RESPONSE TO SUBMISSIONS REPORT CROOKWELL 3 WF

Crookwell 3 Wind Farm Addendum Environmental Impact Statement Response to Submissions

On behalf of
Crookwell Development Pty Ltd

Figure 3 – Proposed Infrastructure Layout

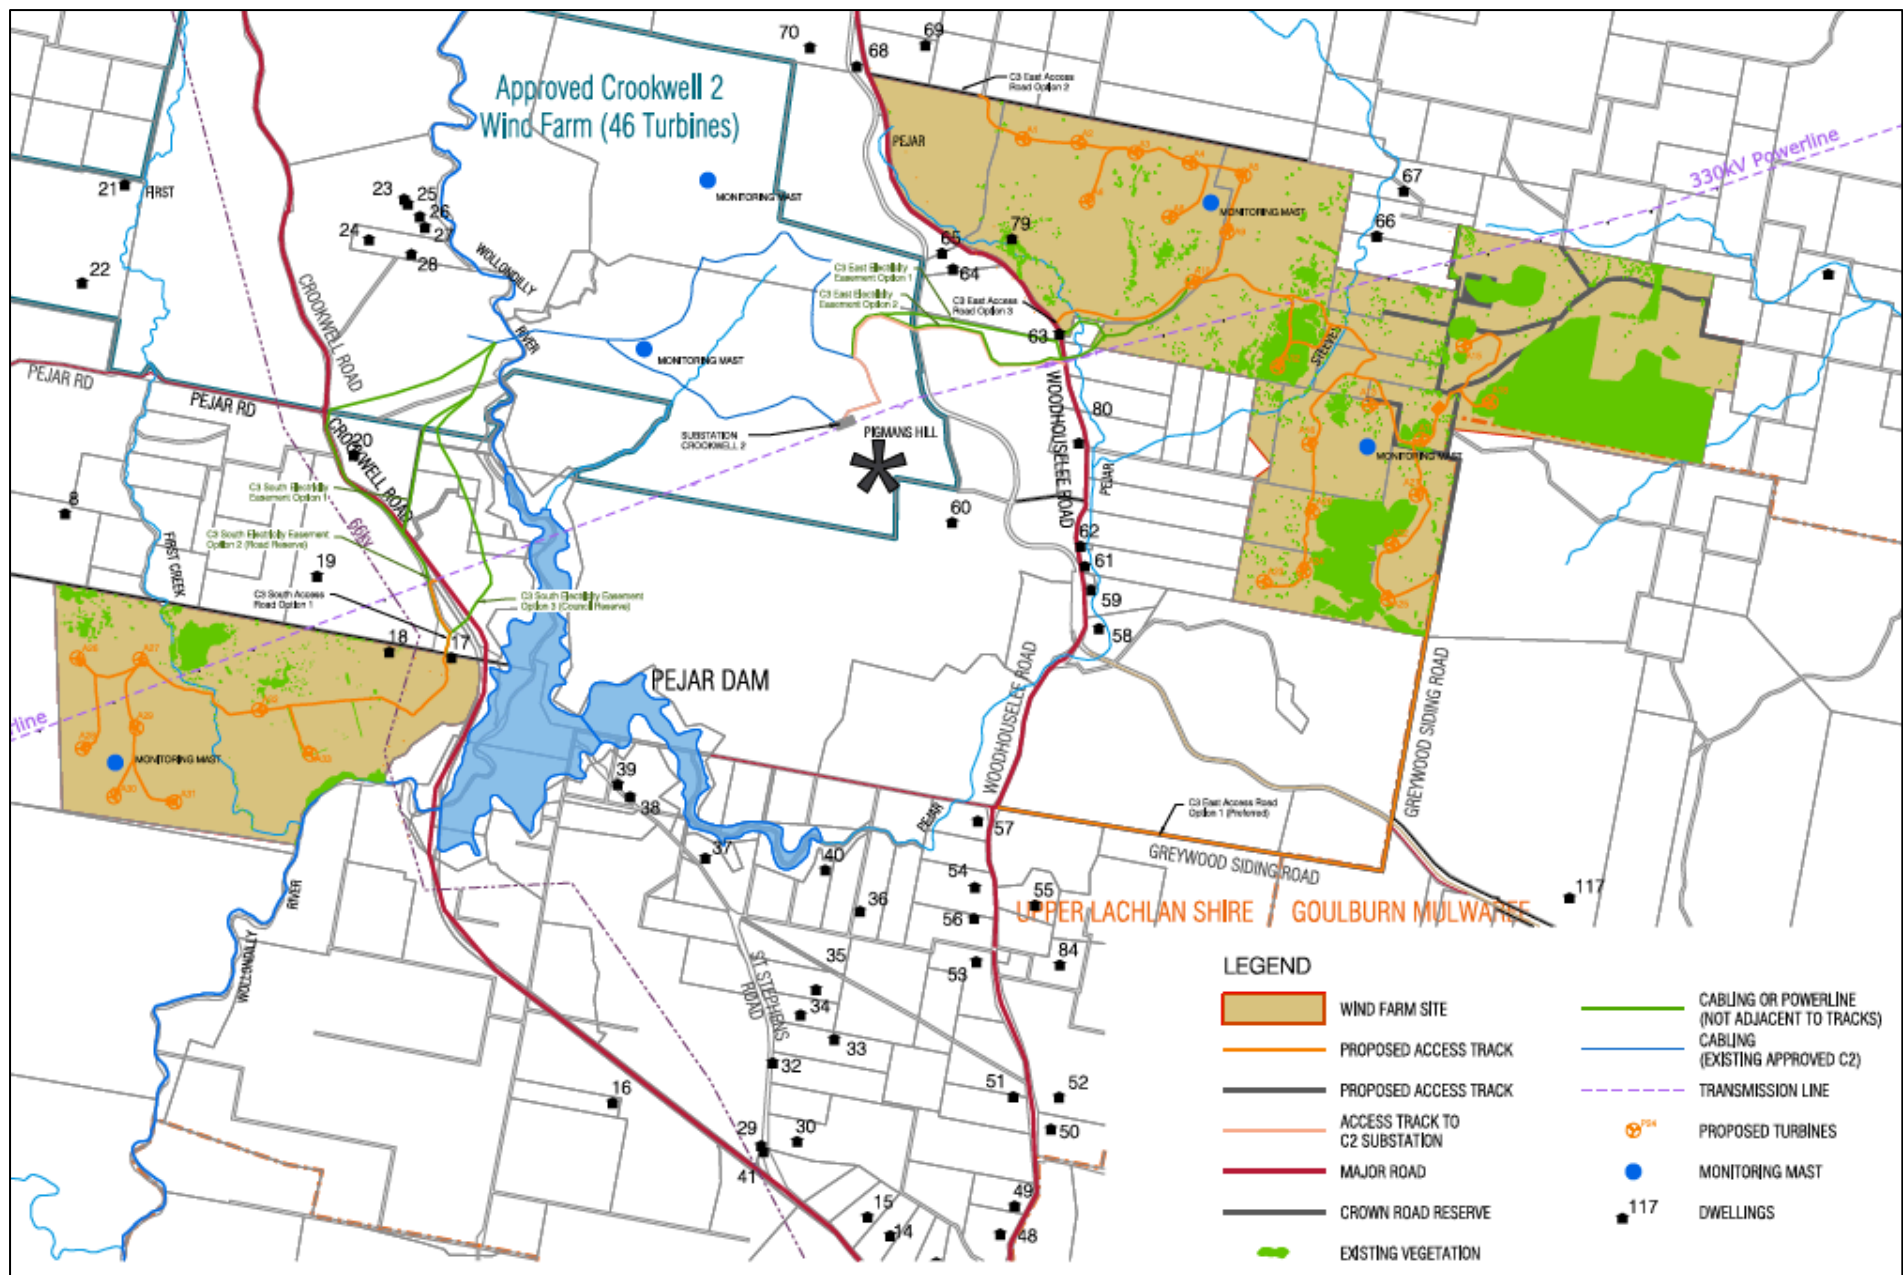
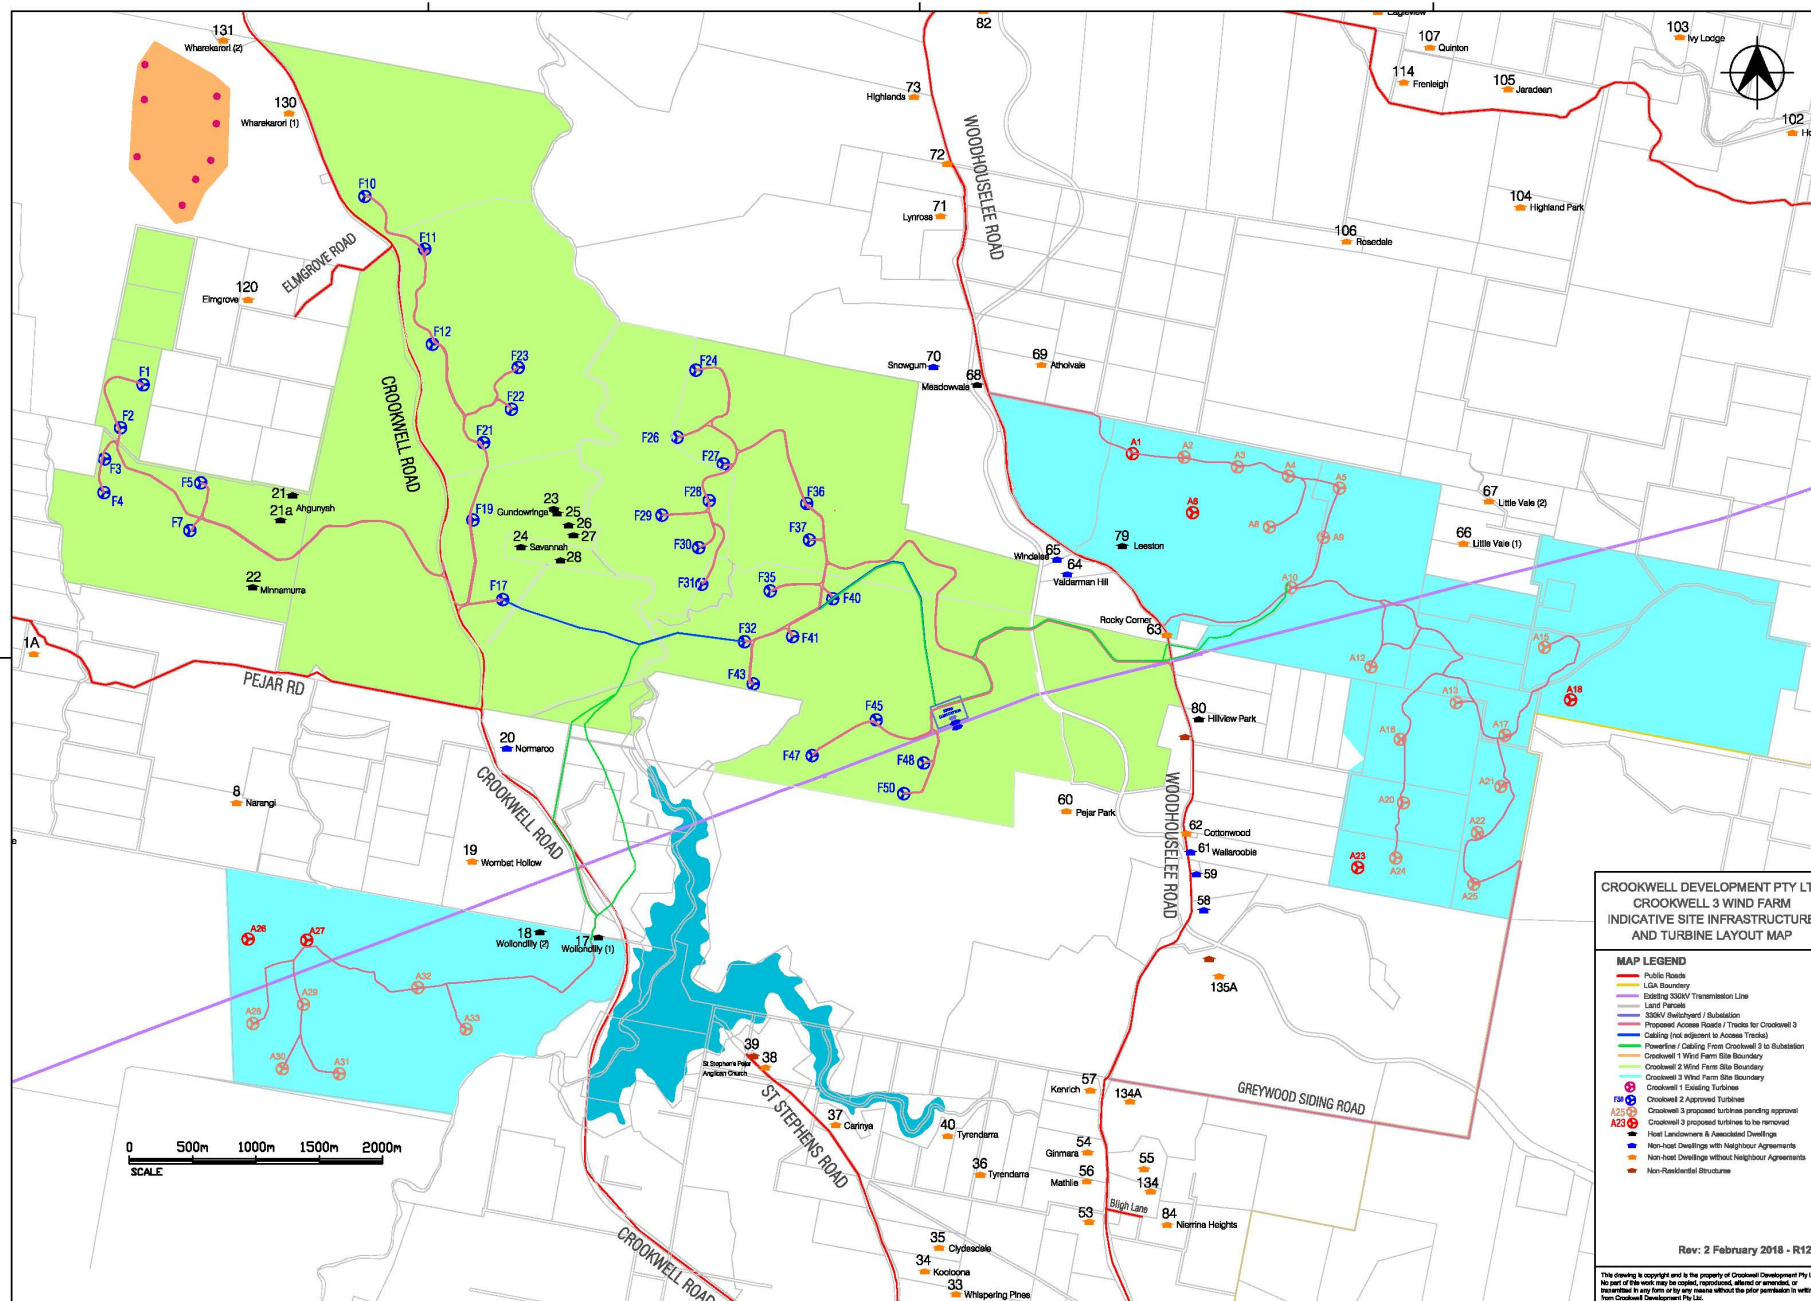
Figure 2 below shows the Crookwell 3 Wind Farm infrastructure layout presented under the Preferred Project and Response to Submissions Report (PPRSR), while Figure 3 indicates the amended proposed infrastructure layout incorporating the changes described above.

Figure POS 1 C3WF Amendment and approved C2WF

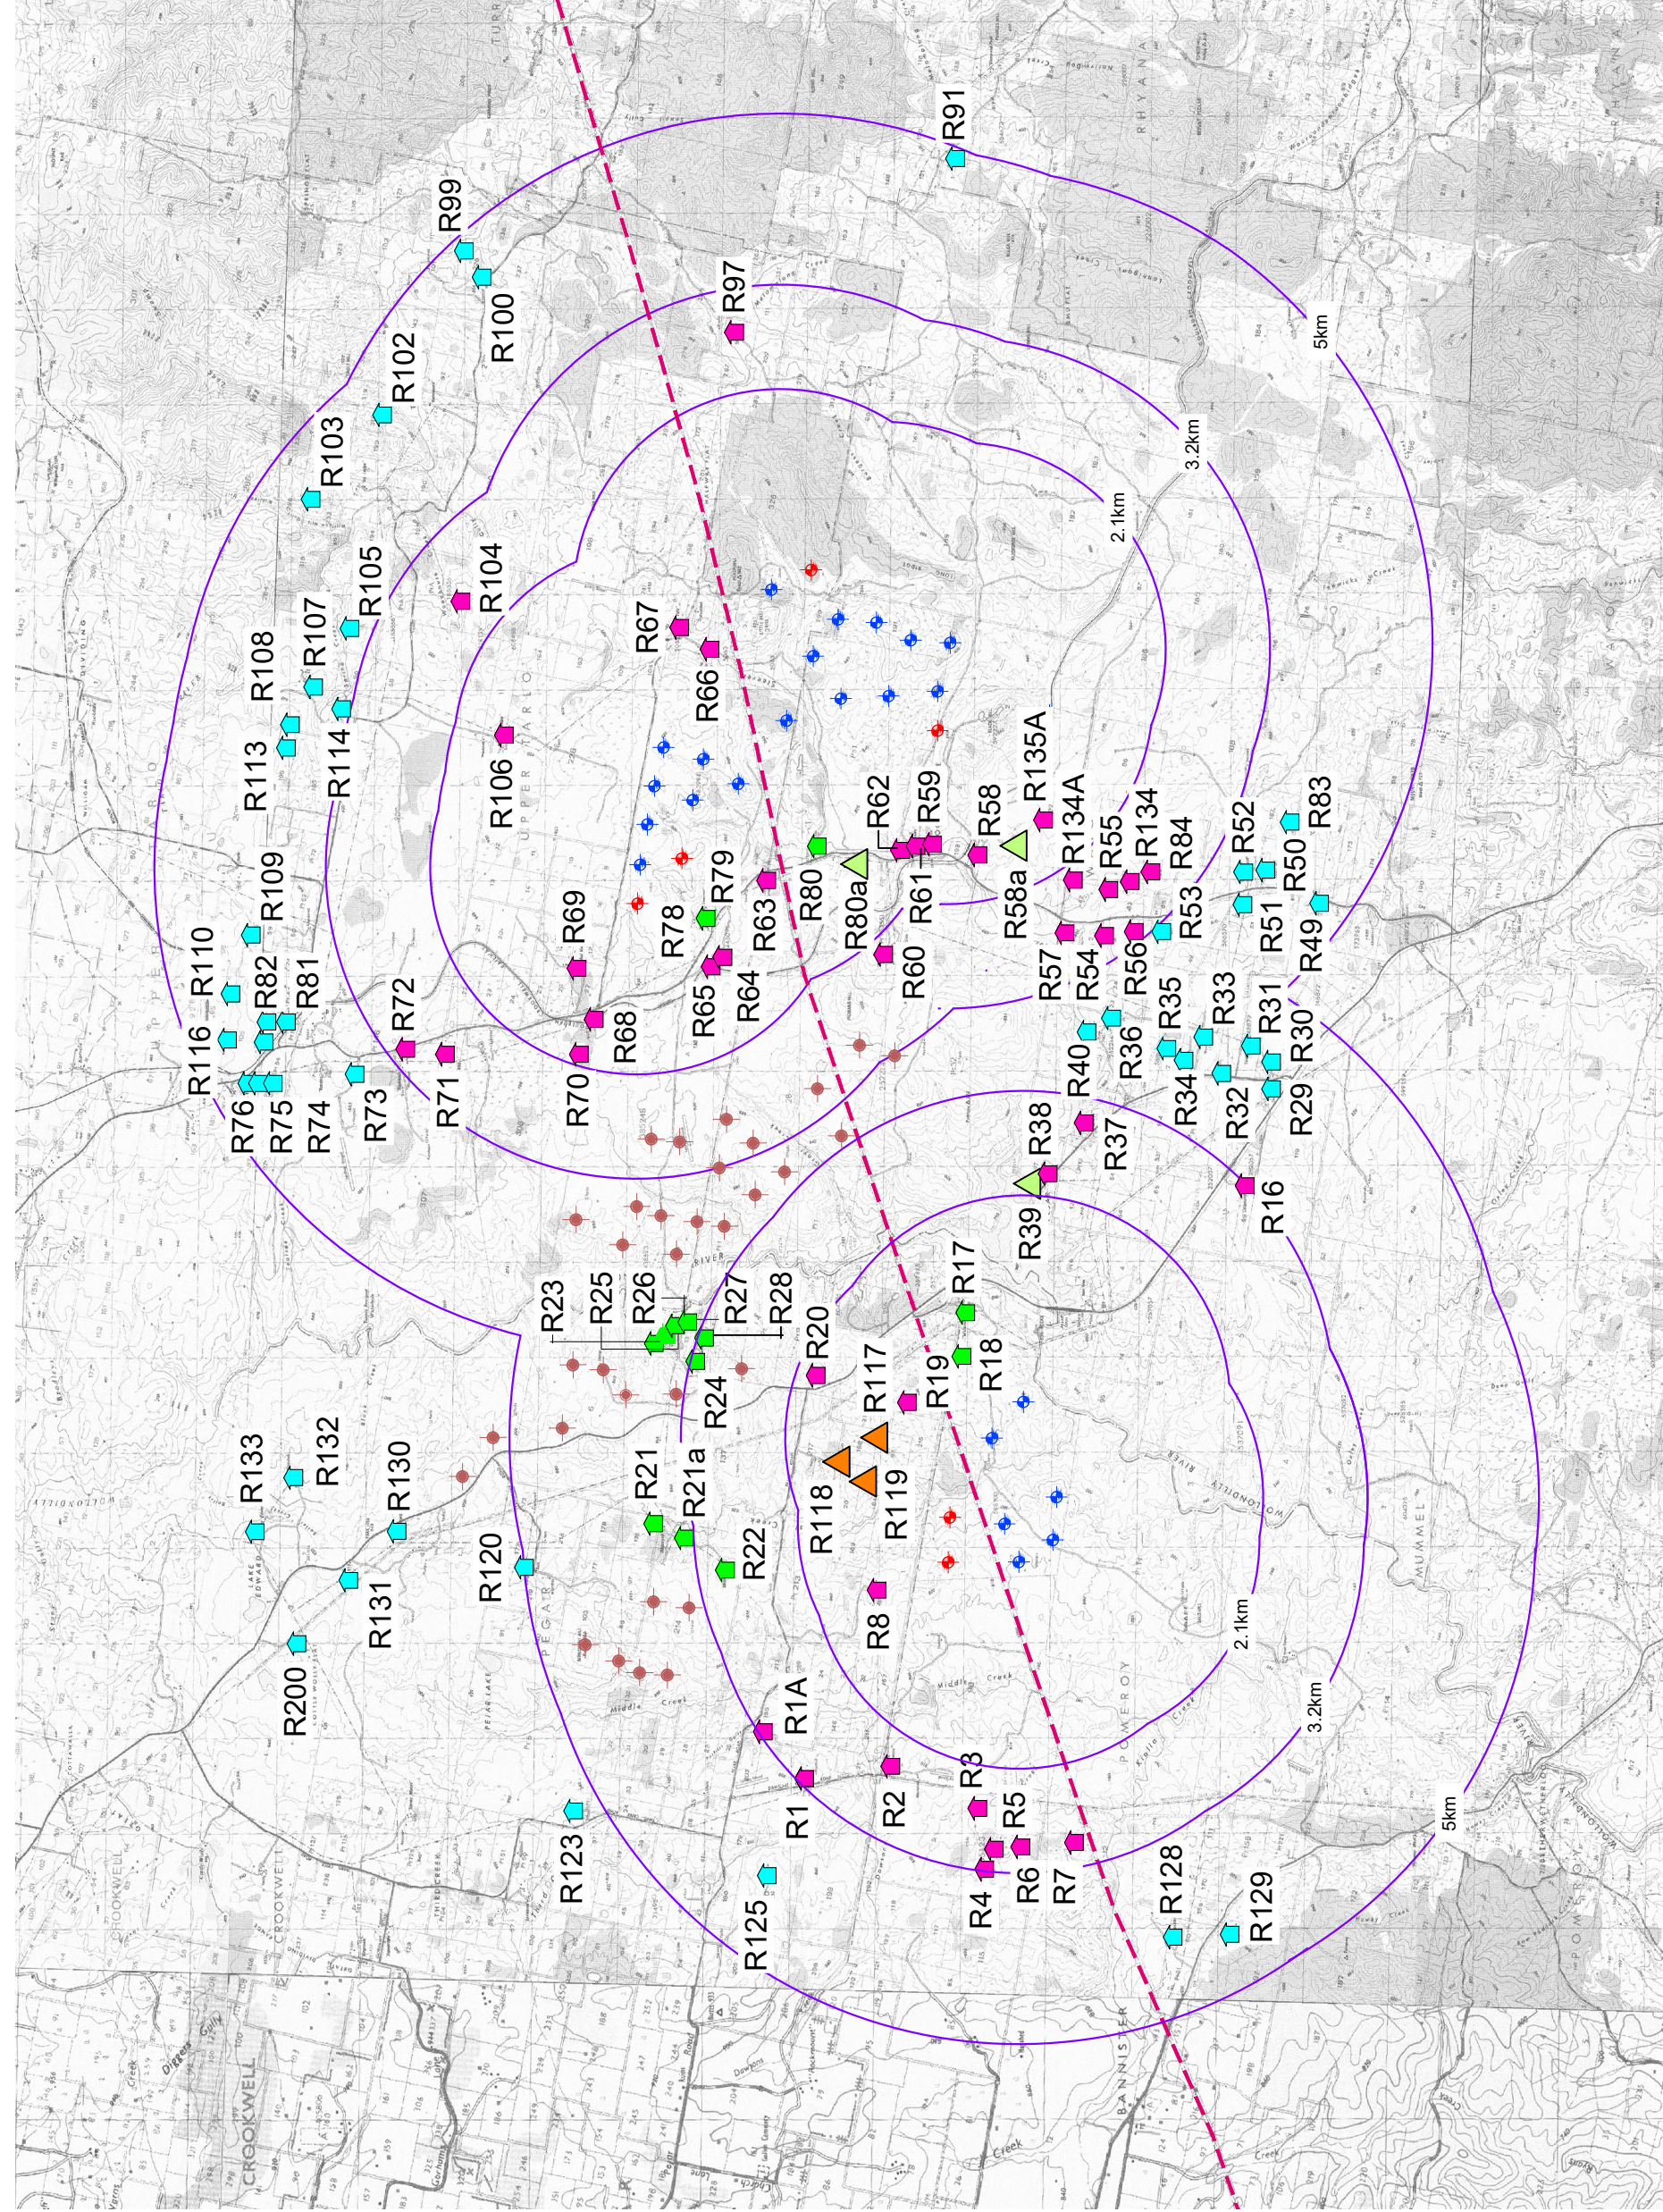
Update to C3WF Amendment Figure 1

The C3WF Amended VIA Figure 1 has been updated to:

The updated C3WF Amended VIA Figure 1 is included in Appendix A – Figures as C3WF PS01.

Figure 1 Location of dwelling 135a relative to the proposed Crookwell 3 Wind Farm and assumed shadow flicker distance limit

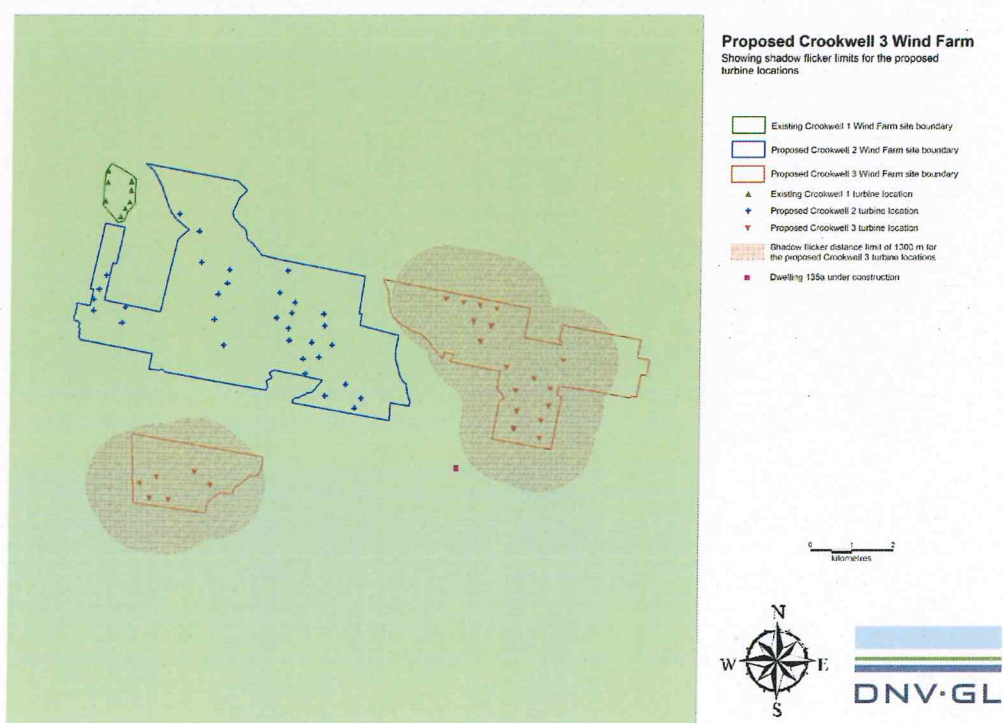
In the assessment, 'dwelling 135a' is located 1.7km from the nearest turbine of the proposed Wind Farm and it is considered that the potential to cause annoyance to this dwelling would not constitute as a problem (see Figure 1 of Appendix 4). Refer to Table 12 above for further discussion.

This assessment has considered the potential shadow flicker impacts on dwelling 135a, which is currently under construction on the Macourt property. Figure 1 shows the location of dwelling 135a in relation to the Crookwell 3 Wind Farm. The 1300 m distance limit for shadow flicker impacts from turbines at the Crookwell 3 Wind Farm is also illustrated in Figure 1. Since dwelling 135a is located 1.7 km from the nearest turbine, or approximately 400 m beyond the maximum distance at which shadow flicker is likely to cause annoyance, it is not expected that shadow flicker from the Crookwell 3 Wind Farm will be a problem at this dwelling.
